Northside West Health Clinic - Stormwater Management Plan and Water Sensitive Urban Design

Stellen Consulting was engaged to assess the proposed development at 23-27 Lytton St, Wentworthville in reference to stormwater quantity and quality. Our previous report of 21 November 2021 outlines the proposed concept stormwater management system and its assessment in accordance with the relevant requirements of Holroyd Development Control Plan 2013.

Council responded with a series of technical comments on 13 April 2022.

Below is a summary of the design amendments and responses to these comments.

Existing and proposed projects overlaid on overland 1% AEP flood extents (Source: Finlaysons Creek Overland Flow Study (2017))

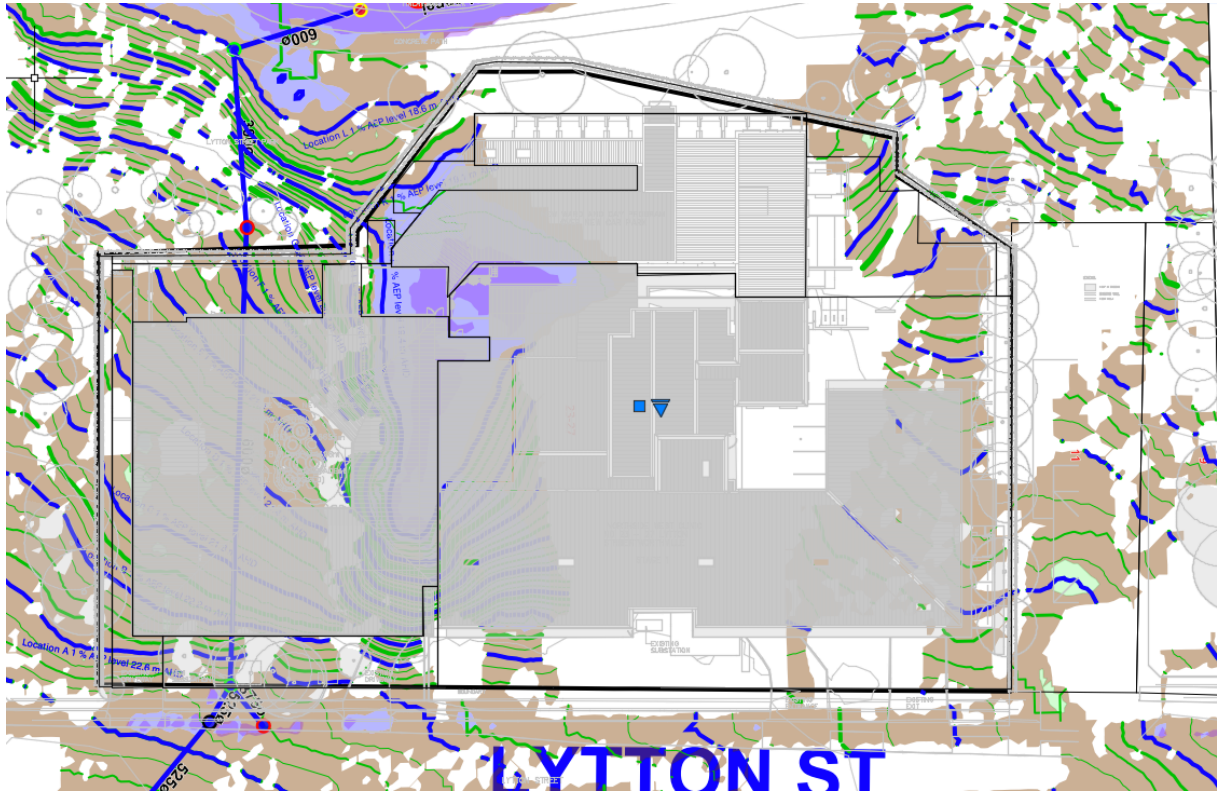
2. Onsite stormwater detention shall be provided for entire site. In this regard,

i. stormwater plans shall clearly show the contributing catchments to the OSD system. As built OSD details and calculations shall be submitted.

ii. OSD for the area that is located outside the contributing catchment shall be provided. Detail calculations shall be provided.

iii. OSD shall comply with Council's DCP and Upper Parramatta River Catchment Trust "On-Site Detention Handbook".

The approved and constructed Stage 1 OSD allowed for only 884m² of the existing roof to detention of the entire site. Refer attached drawing 2014-0241 H01/B by AJW dated 17/9/14 outlining the total impervious area originally designed for (approximately 5405m² or 81% of the site), and the total proposed impervious area (5455 or 82% of the site). In accordance with Cumberland Council OSD Policy (s4.8), the approved detention strategy excluded portions of the property subject to overland flow (as known at the time of design).

This proportion has increased with further modelling and now includes significant portions of both the original Stage 1 area and all of the Stage 2 (current proposal) area.

The current proposal area is therefore excluded from the OSD policy in the same way it was excluded in the Stage 1 design.

This is sensible policy because detention tanks in such low positions in the catchment not only fill with overland flow, becoming redundant when they are needed most, but also serve to compound the site discharge with the broader catchment peak flows.

Notwithstanding this, as discussed with council engineers on 27 April 2022, the proposed impervious area is approximately 45m² more than the area in the approved design for Stage 1. This small increase is immaterial to the function of the existing approved OSD system.
